Report Type: DA Access Report
Reference Number: 20309
Client: Hume Community Housing
Site Address: 23-25 Charles St, Liverpool NSW

ACCESS REPORT

This Access Compliance Report is to accompany a Development Application for the development proposed at 23-25 Charles St, Liverpool NSW

This development proposes a New Building with a total of 23 Residential units. The development is within Liverpool City Council LGA that requires the provision of 10% Adaptable units and therefore the development proposes 3 Adaptable units. A total of 3 Accessible parking spaces has been provided in the development.

Units 6 and 10 shown below.

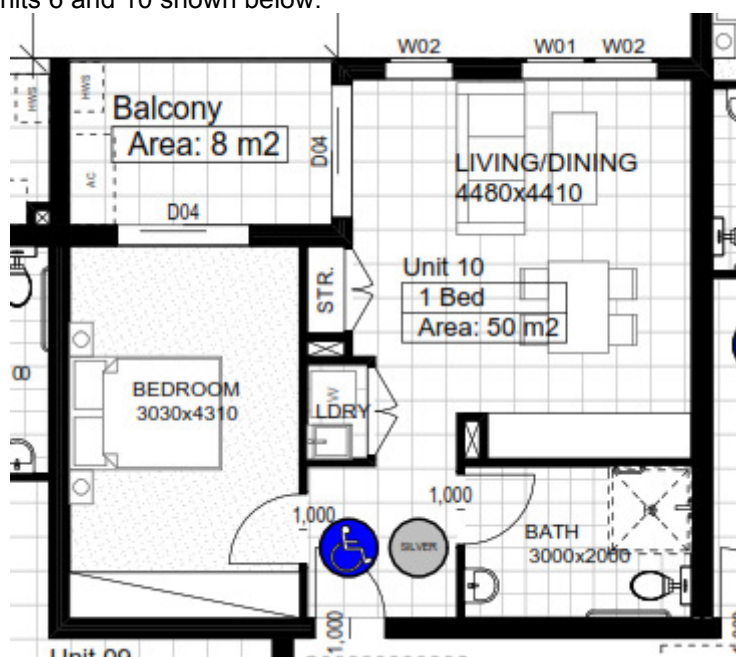
- Note that ALL internal passageways are required to be 1M clear when measured from skirting to skirting so allow for the same.
- Note that the wet areas are to be such that flush transition is available. One way of achieving this is to recess the floor slab.
